UNITED STATES PATENT AND TRADEMARK OFFICE

10/599,286

Office Action Summary	Application No. 10/599,286	Applicant(s) DODO ET AL.	
	Examiner William R. Harp	Art Unit 4174

DETAILED ACTION

FIG. 5

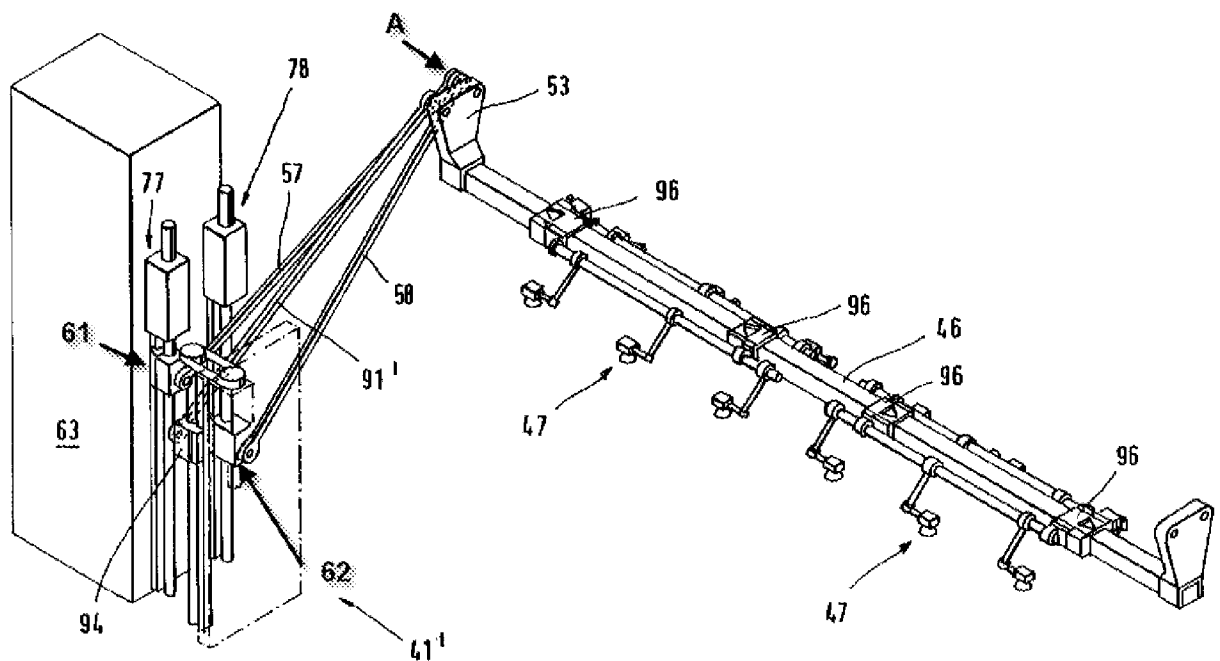
6. Regarding Claim 1, Hofele et al. teaches a panel carrying device (41 in Figure 3) comprising: a panel holding device (46 and 47 in Figure 3); a second link mechanism (58 in Figure 6) connected to the panel holding device (through element 53 illustrated in Figure 5); a

first link mechanism (57 in Figure 6) pivotally fitted to the second link mechanism; a slide mechanism (77 & 61, 78 & 62, 94 in Figure 5) which moves the first link mechanism in a panel carrying direction; and a swing mechanism (77 & 61, 78 & 62, 94 in Figure 5) which swings the second link mechanism. The action of elements 77, 78, and 94 cause the first link mechanism 57 to be moved in the panel carrying direction as illustrated in Figure 6 and causes the second link mechanism to be swung (the center of mass of the link would follow an arcing path through its movement) [C6, L17-37].

11. Regarding Claim 8, the first and second link mechanisms are pivotally fitted at Point A in Figure 5 of Hofele et al. to each other and member (53). The translatable actuator (78) causes the

links to swing; therefore, the examiner considers the combination to be a swinging link mechanism.

22. Regarding Claim 5, Hofele et al. teaches the device of Claim 1. Hofele further teaches a feed slide (62) to which a link is pivotally fitted (illustrated in both Figures 3 and Figures 5) as well as a translatory actuator (78 in Figure 5) which drives the feed slide.

FIG. 3

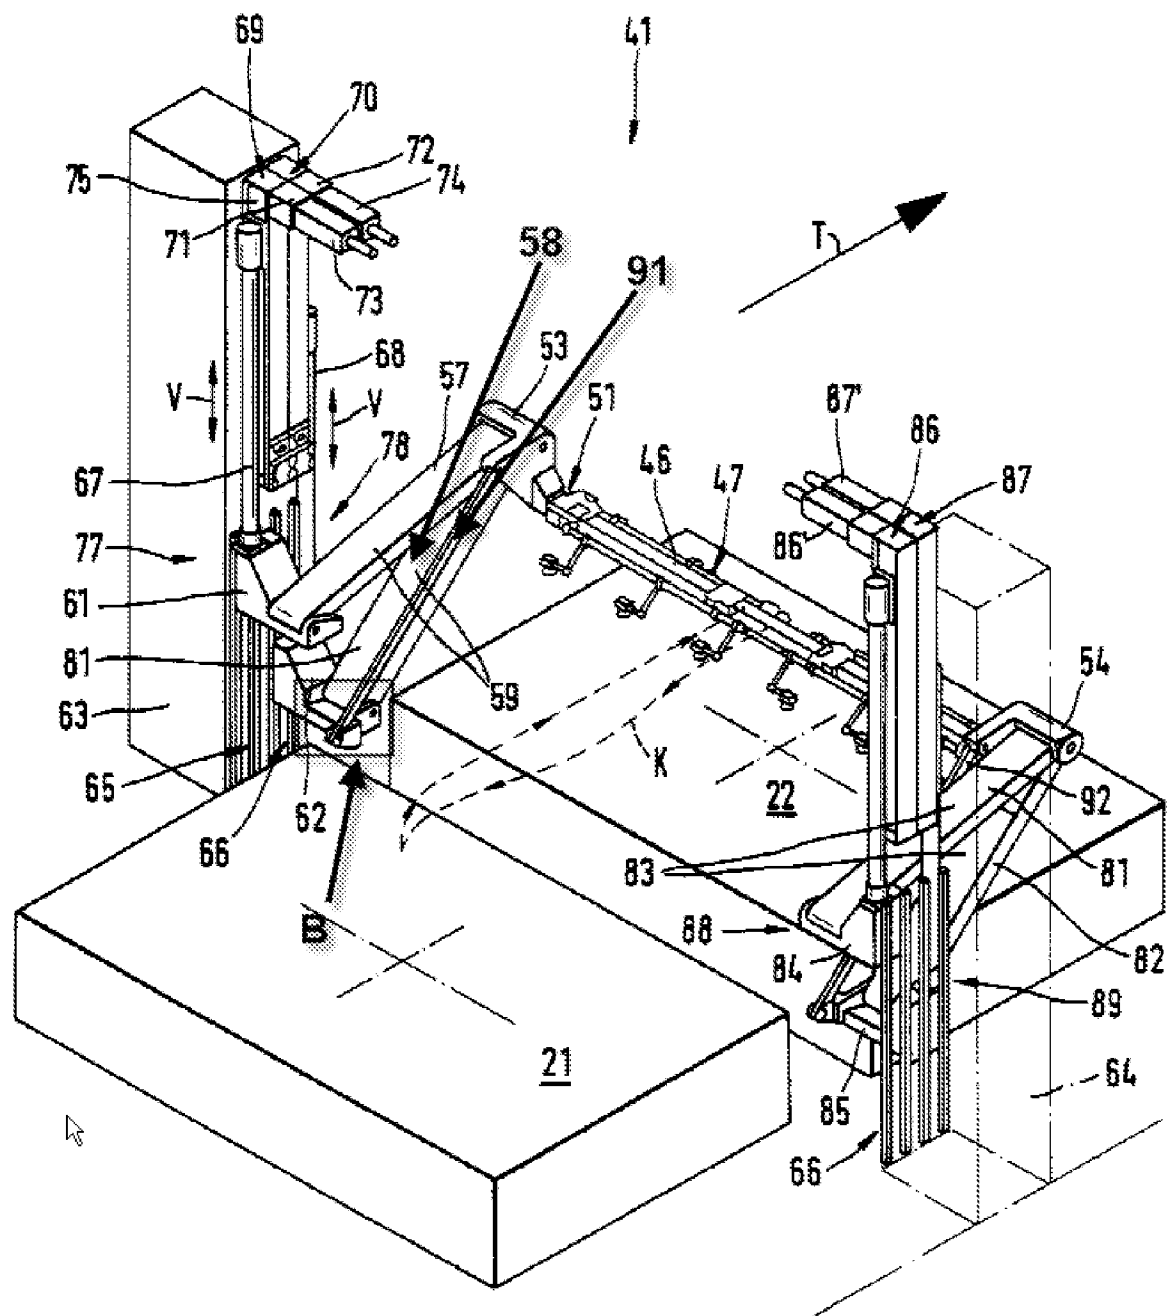
8. Regarding Claim 2, Hofele et al. teaches pairs of link mechanisms, slide and swing mechanisms on opposite sides of the panel holding device arranged symmetrically with respect to each other (Figure 3).

9. Regarding Claim 3, Hofele et al. teaches an output member (53 in Figure 3) connected to the panel holding device. Hofele et al. further teaches two arms (58 and 91 in Figure 3) which constitute a parallel link connected to a slide (62 in Figure 3). The portion (B in Figure 3) of slide (62) is considered to be an intermediate member.

14. Regarding Claim 14, Hofele et al. teaches a cross bar (46) connected to the second link mechanism (through member 53) and a work holding tool (47) attached to the cross bar.

18. Regarding Claim 4, Hofele et al. teaches the panel carrying device of Claim 3. Figure 3 of Hofele et al. illustrates that the intermediate member is attached to the slide (62). Hofele et al. fails to teach two arms connecting the intermediate member to the slide mechanism.
